Overview: Production error; immobilizer wire (orange/black) in pin position #4 instead of pin position #5. Although an effort to correct the issue was made, some quantity of harnesses did get shipped before the issue was spotted. We are advising to inspect the harness BLADE connector before attempting to install the harness and program the module.

Descripción general: El nuevo arnés en T FTI-STP1 requiere modificaciones para su uso en aplicaciones de transmisión automática (AT).

FTI-STP1: Notas de instalación y configuración

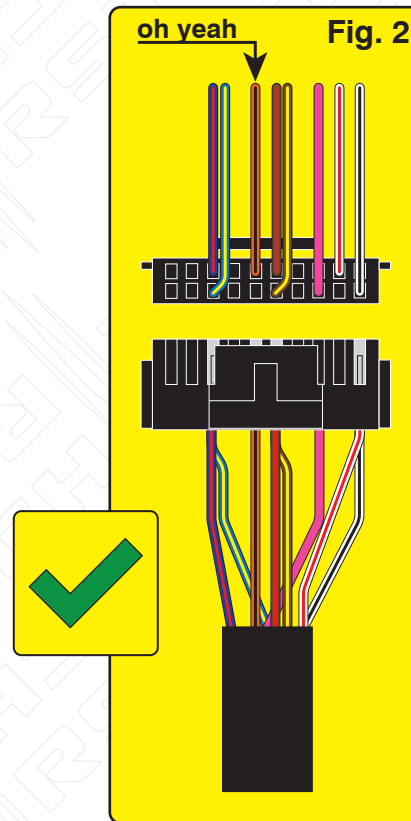
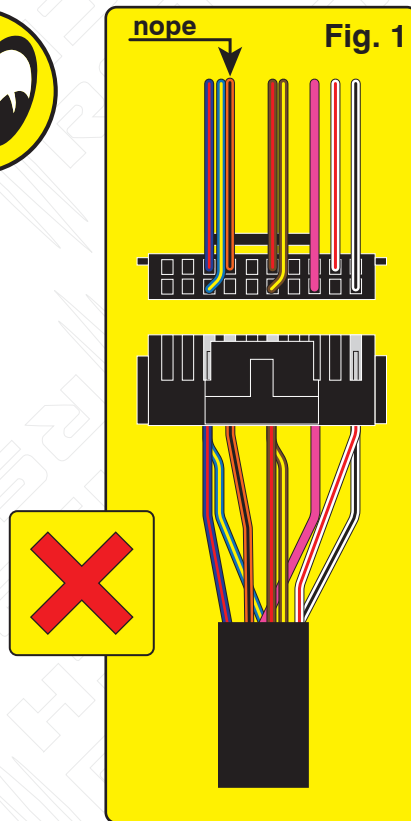
Issue: Module fails to program to vehicle, will not allow the vehicle to be remote started.

Correction: Step 1.) Locate the orange/black wire and confirm whether it is positioned as illustrated in Fig. 1 or Fig. 2. If the wire is as illustrated in Fig.1, proceed with Step 2 through 5 and complete the repair procedure outlined, if the wire is as illustrated in Fig. 2, correction is not necessary, proceed with harness installation and module programming.

Step 2.) Using a pick, lightly depress the catch that secures the terminal in the housing then remove the wire and terminal from the housing.

Step 3.) Using a fine tip razor or utility knife, insert the blade beneath the terminal catch and raise it slightly, so that it can be reused to secure the terminal when reinserted into the BLADE connector housing.

Step 4.) Refer to Fig. 2 for correct position of the orange/black wire (next to brown/red) then reinsert the terminal, pressing lightly until the catch 'snaps' into place, securing the terminal in the connector housing.

Step 5.) The repair is complete, proceed with installation and programming.

MODIFICACIÓN REQUERIDA PARA APLICACIONES DE TRANSMISIÓN AUTOMÁTICA ÚNICAMENTE

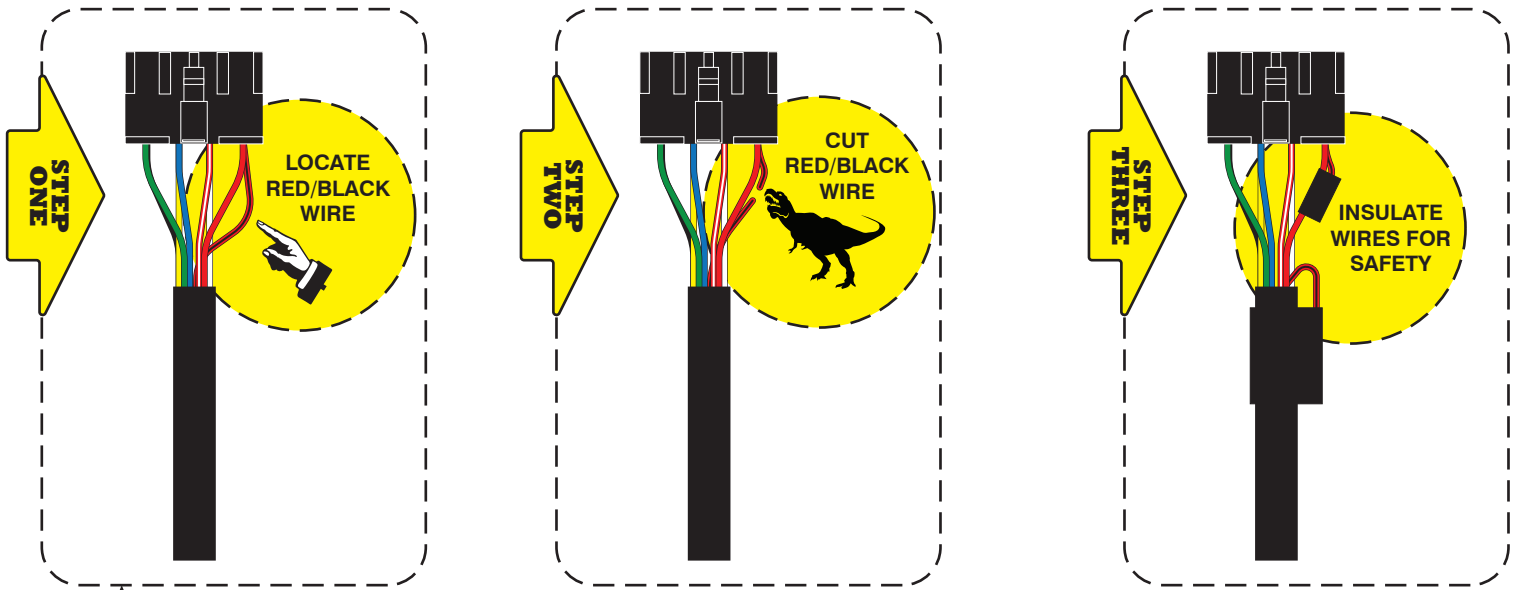
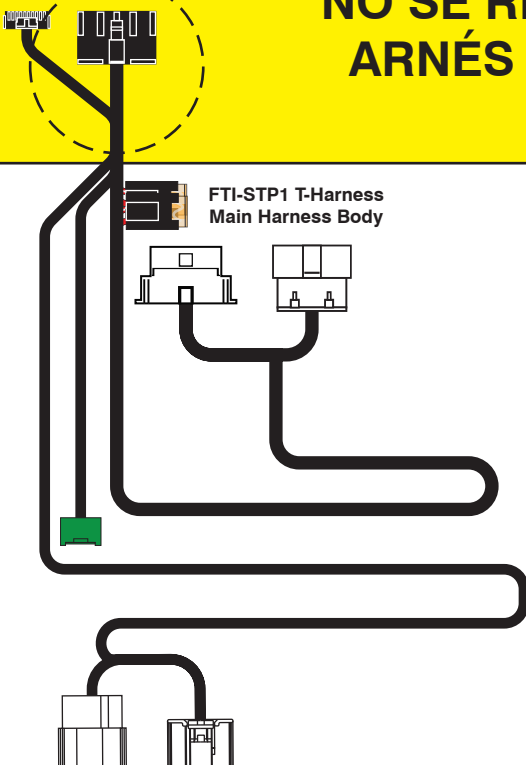
Problema: El arnés en T FTI-STP1 ha sido diseñado para ser compatible con AT (transmisión automática) y MT (transmisión manual), pero debido a una supervisión de la producción, el mecanismo de selección se estableció por defecto en el modo MT.

El uso de un arnés configurado para una aplicación MT, en un vehículo equipado con AT, podría provocar daños en el módulo del vehículo. Se recomienda que el arnés vuelva al modo AT antes de instalarlo en vehículos equipados con transmisión automática.

Corrección: Localice el cable rojo/negro (+ embrague) provisto en el conector CN1 del conjunto del arnés principal. Corte el cable rojo / negro, ya sea al ras del conector CN1 o dejando suficiente cable expuesto para que pueda aislar y asegure los extremos del alambre que quedan después del corte. Aísle cada uno de los extremos restantes del cable rojo/negro y asegúrelos para evitar cualquier posibilidad de cortocircuito.
